stm32-blinky — Design Document

hwde v1 pipeline
generated 2026-09-24 12:39:06

Board review: stm32-blinky (P8 adversarial pass)

reports/renderers/stm32-blinky_top.png

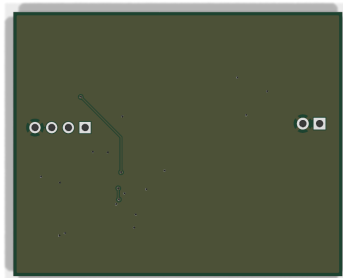
ERROR 1 - J1 power input has no polarity legend on silk (requirements miss)

requirements.md sec 2 and architecture/blocks.md both promise the 5 V input "polarity marked on silkscreen" (J1 pin 1 = +5 V, pin 2 = GND). The as-built board has NO text or +/- legend anywhere: silk carries refdes only (there is not a single gr_text on the board). What exists at J1 is a pin-1 dot and a square pad (see crop-j1_d1.png) - and the dot sits on the header body outline,

so after the header is soldered the plastic covers it. Post assembly the top side shows nothing but "J1"; the square pad is visible only from the bottom.

Consequence: the unkeyed 2-pin input can be plugged backwards with no on-board hint. D1 (series SS34) prevents damage - reversed input just does not conduct - but the user gets a dead board and no way to know why or which way is right without opening the design files. This is the board's primary human interface and an explicit requirements promise. Fix is two silk texts ("5V", "GND" or "+", "-") next to the holes, outside the header body. Must fix before fab; there is ample empty silk area (left region is empty).
